### TSB - MF01

Models applicable > Massey MF350,355,362,365,375,390  
MF4225,4235,5285

#### CLUTCH PLATE and COVER COMPATIBILITY

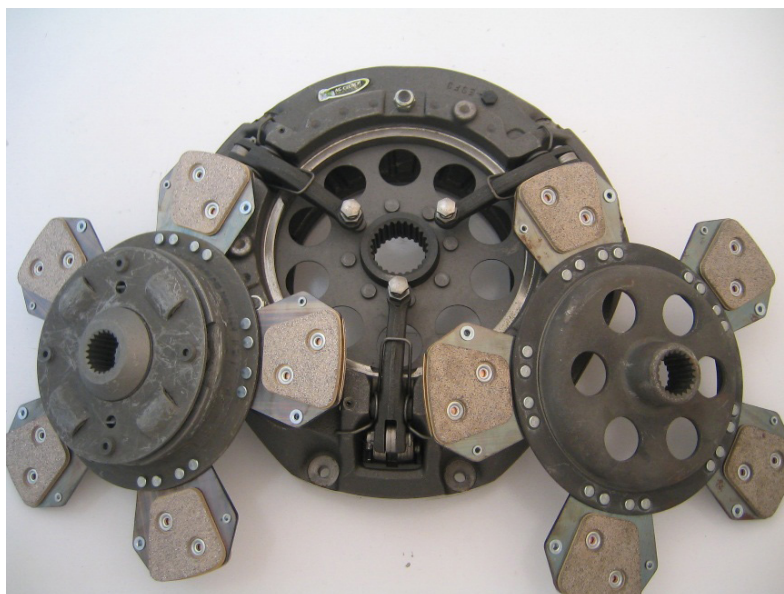
When fitting the LuK cover assembly listed, it is very important to use this in conjunction with the same LuK clutch plates shown. The cover is specially designed to suit the later style heavy duty (10.5mm) discs only - it must not be used with other manufacturer's plates.

The original cover in some models may be designed to be used with thinner discs (9.2mm) and should not be interchanged with the Luk version shown.

Mix matching of covers & discs will cause release problems and/or premature failure of clutch.
